T ECHNICAL INFORMATION

64831

- Subject** ▶ Change of - Flat Head Screw and Keyless Drill Chuck
- For Models** ▶ 8413D, 8433D, 8443D
- Country** ▶ All countries
- Description** ▶ - Flat Head Screw and Keyless Drill Chuck have been changed as illustrated below.

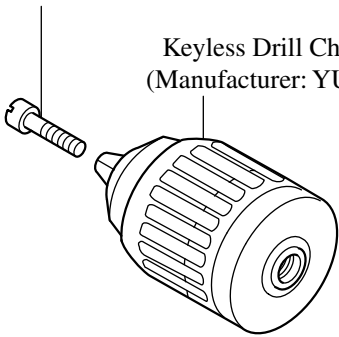
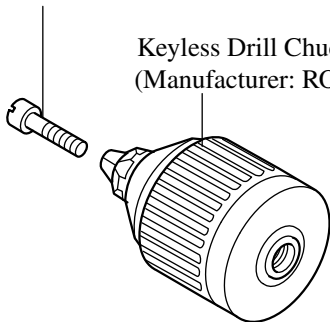
▶ Current	▶ New
<p>- Flat Head Screw M6x32</p> <p>Keyless Drill Chuck 13 (Manufacturer: YUKIWA)</p> 	<p>- Flat Head Screw M6x22</p> <p>Keyless Drill Chuck 13 (Manufacturer: ROHM)</p>

Item No.	Current part		Q'ty	I/C	New part		Q'ty	Note
011	- Flat Head Screw M6x32 251465-1		1	No	- Flat Head Screw M6x22 251464-3		1	Interchangeable as a set
012	Keyless Drill Chuck 13 193064-2		1	No	Keyless Drill Chuck 13 193550-3		1

Item No.	Current part		Q'ty	I/C	New part		Q'ty	Note
011	- Flat Head Screw M6x32 251465-1		1	No	- Flat Head Screw M6x22 251464-3		1	Interchangeable as a set
012	Keyless Drill Chuck 13 193065-0		1	No	Keyless Drill Chuck 13 193551-1		1
